AS-BUILT PLAN REVISIONS
BY Roy A. Galli DATE 12-18-89
RCE 16024
ADD LOC DIMS FOR 8 MILE AND
QUASHNICK RD ON 18" S.D. INLET DET.
ADDED SHEETS 28A & 28B

MORADA ESTATES NORTH
SAN JOAQUIN COUNTY

STREET IMPROVEMENT PLANS: MORADA ESTATES NORTH

STORM DRAIN PLAN
MORADA ESTATES NORTH
SAN JOAQUIN COUNTY

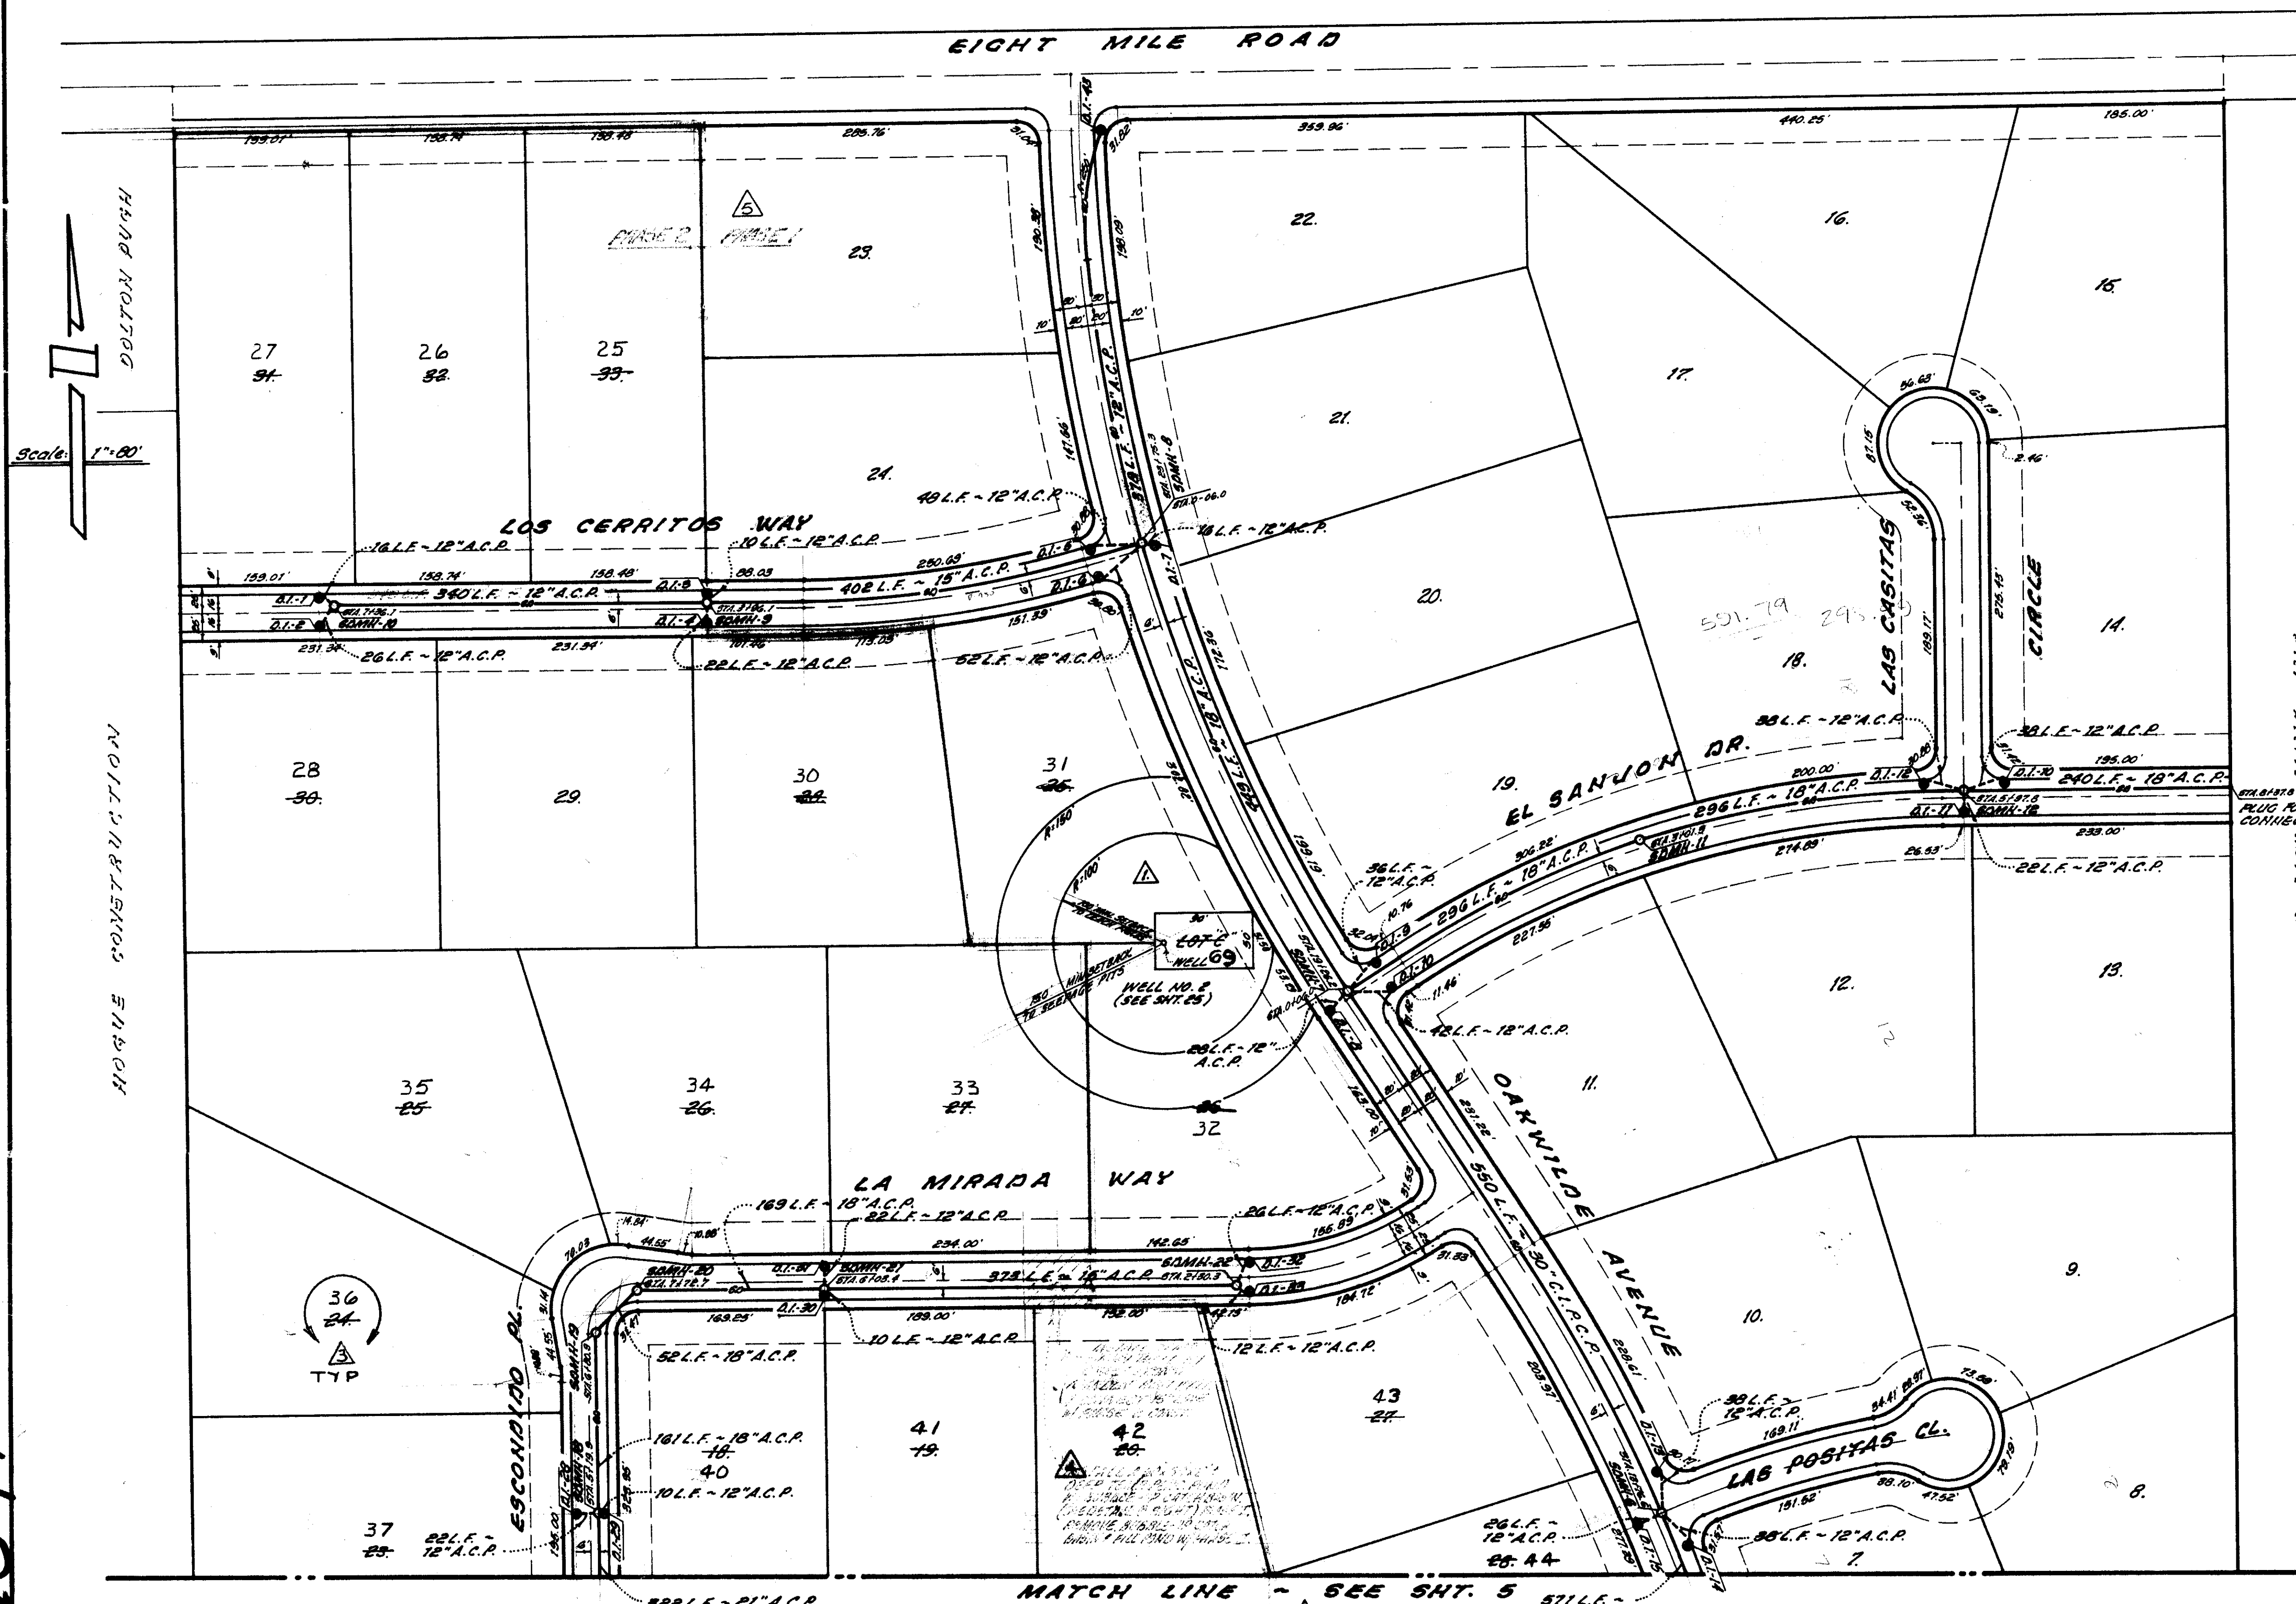
"AS-BUILT" PLAN REVISIONS
BY: Roy A. Galli DATE: 12-18-89
RCE 16024
CROSSED OUT TEMP. POND & ADDED NOTE
REVISE LOT NO'S
REMOVE TEMP. C.B. AND NOTE
REMOVE PHASE LINE & NOTE

GRADING AND DRAINAGE PLAN
MORADA ESTATES NORTH
SAN JOAQUIN COUNTY

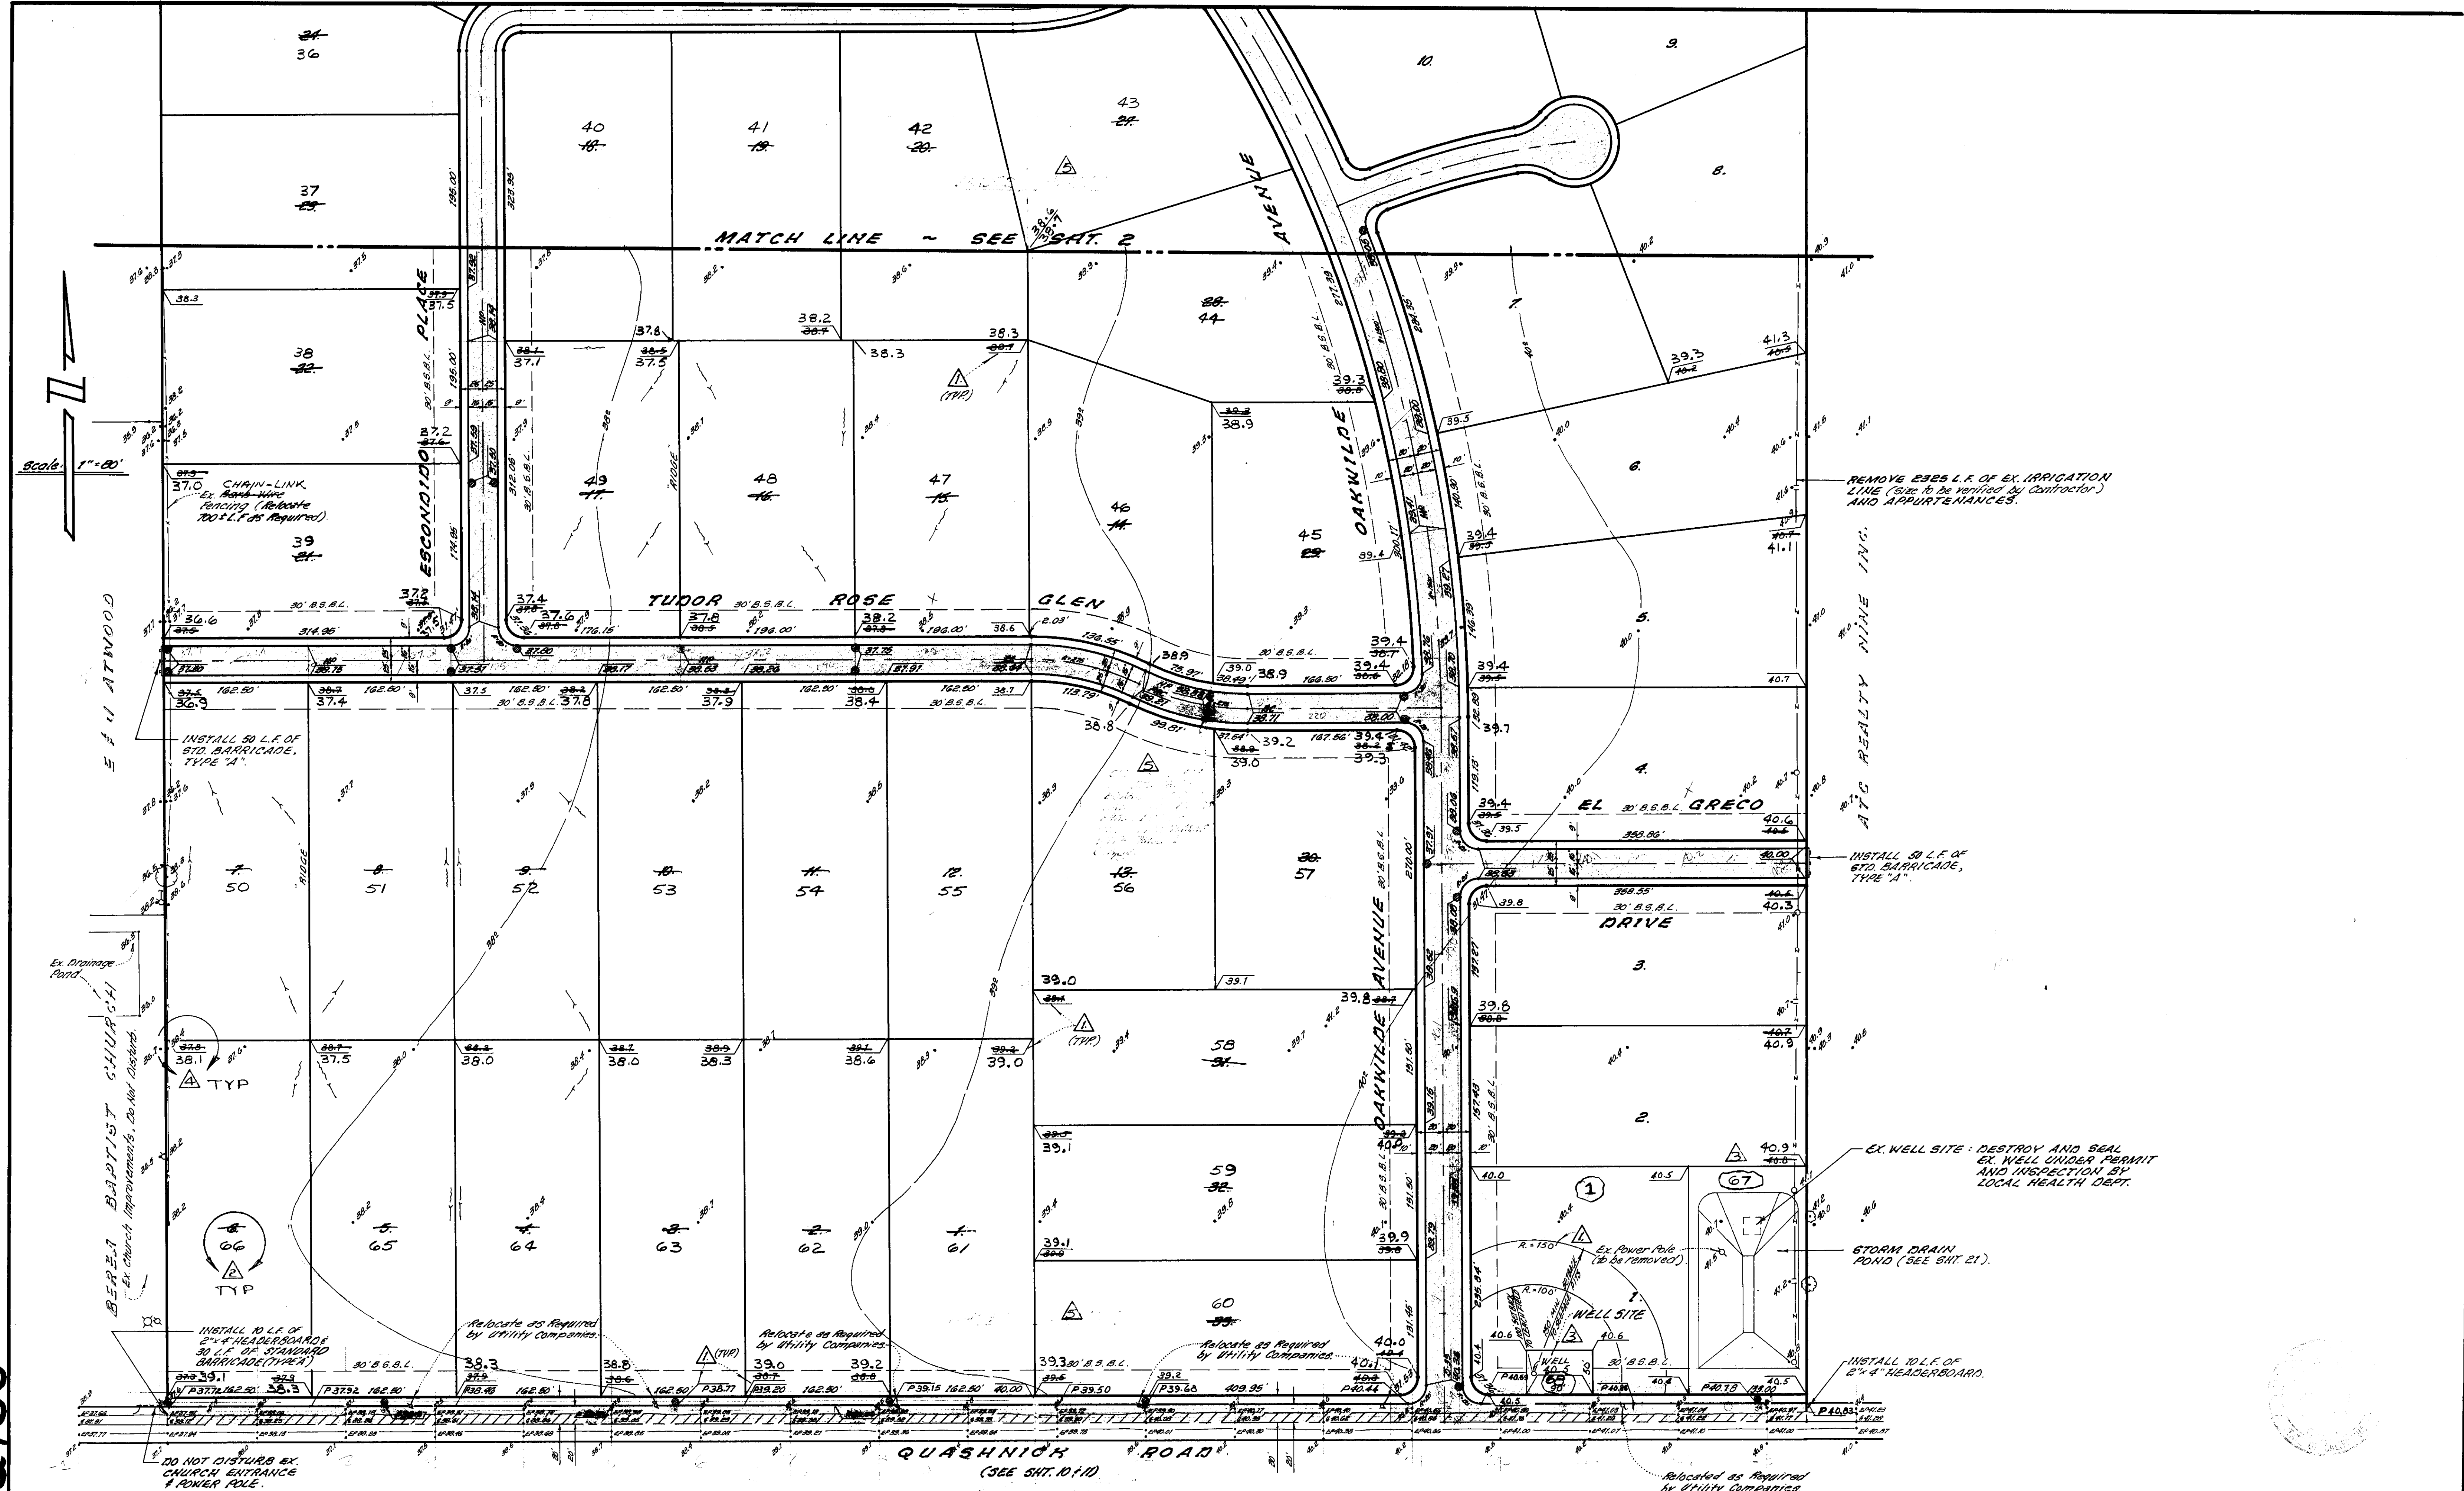
- BY Roy A. Galli DATE 12-18-89
RCE 16024
- ▲ REVISE LOT NO'S
 - ▲ ADD LOTS 67 AND 68
 - ▲ REVISE GRADE ELEVATIONS
 - ▲ REMOVE PHASE LINE & NOTES
